SUBJECT: TECHNICAL ASSISTANCE REQUEST: MERCK & CO.,  
INC.; RELEASE OF INCINERATOR ASH AS NORMAL  
WASTE PURSUANT TO 10 CFR 20.302.

REQUEST FOR TECHNICAL ASSISTANCE

LICENSEE: MERCK & CO., INC. LICENSE NO. 29-00117-06

RE: License No. 29-00117-06  
Docket No. 030-14680  
Control No. 114240

SITE PLAN  
0 500

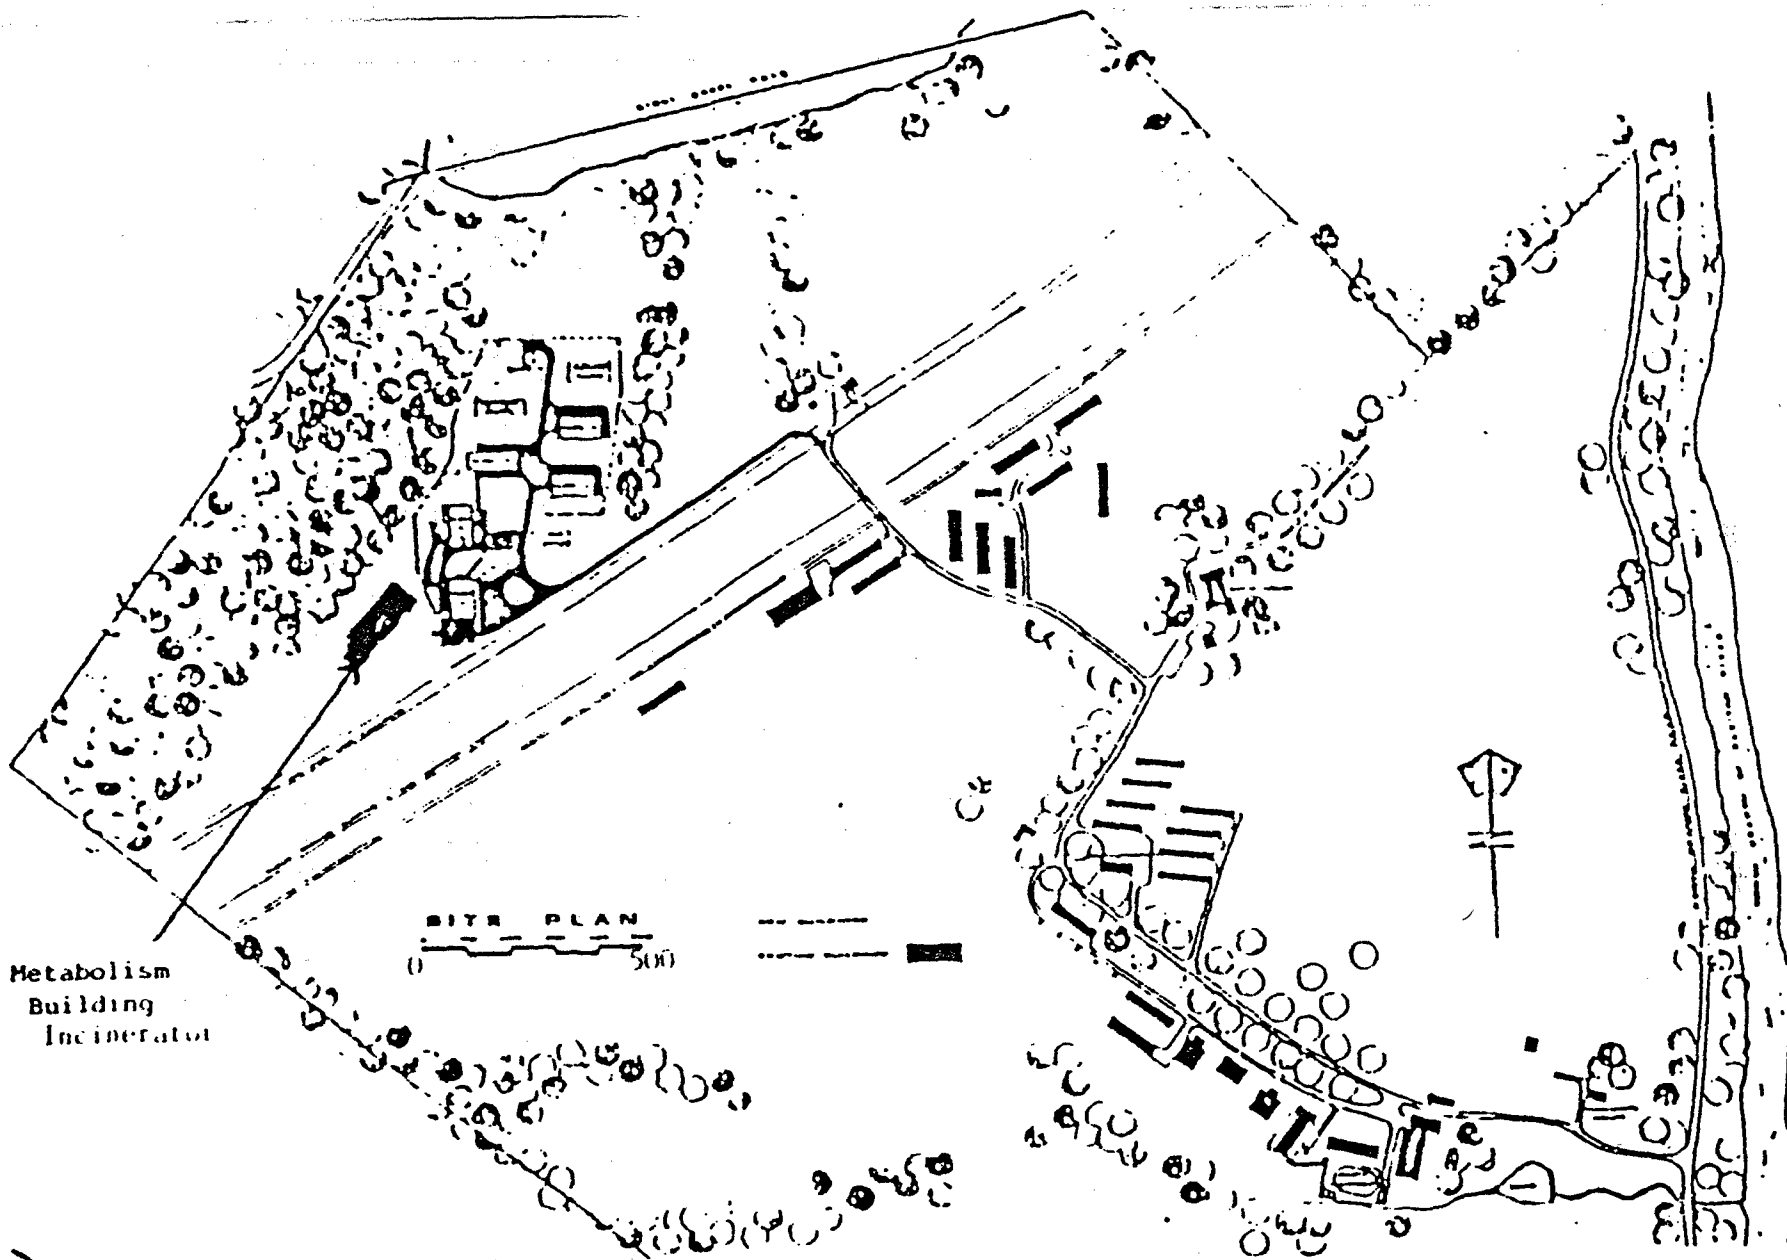
2. Submit a simple scaled drawing showing the location of the incinerator and the distance to the nearest occupied area, structure or air intake.

Please see attached drawing.
